Proposal for amendments to ECE/TRANS/WP.29/GRPE/2016/3 (gtr No. 15 - WLTP)

Submitted by the expert from OICA

This document is a proposal to amend and complete the GRPE working document ECE/TRANS/WP.29/GRPE/2016/3, submitted by the Informal Working Group on Worldwide harmonised Light vehicles Test Procedure (WLTP).

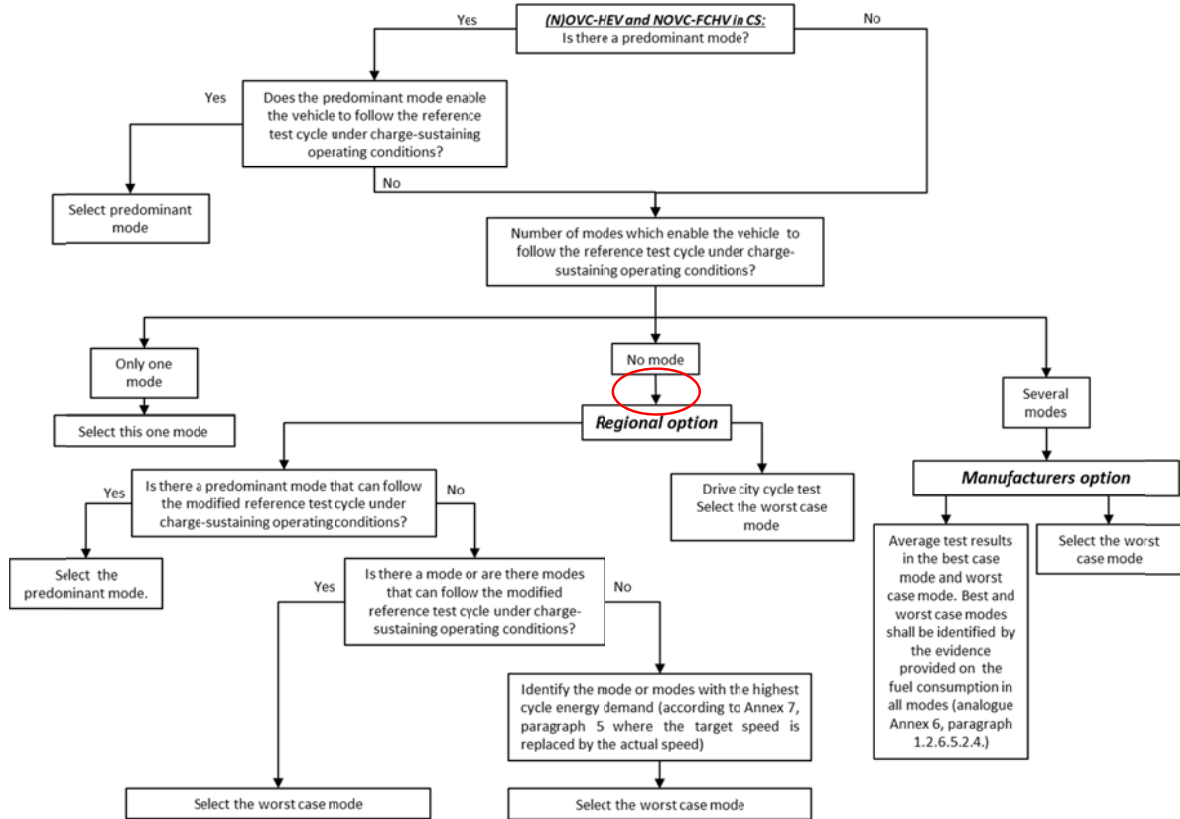
Amend paragraph 3.2. to read:

“3.2. If there is no predominant mode or if there is a predominant mode but this mode does not enable the vehicle to follow the reference test cycle under charge-sustaining operating condition, the mode for the test shall be selected according to the following conditions:

- (a) If ~~this is a single~~ **there is only one mode which allows the vehicle to follow the reference test cycle under charge-sustaining operating conditions**, this mode shall be selected;
- (b) If several modes are capable of following the reference test cycle **under charge-sustaining operating conditions**, the most electric energy consuming mode of those shall be selected.”

In Figure A8.App6/2 insert an arrow from the box “No mode” to the box “Regional option” as shown:

Justification:
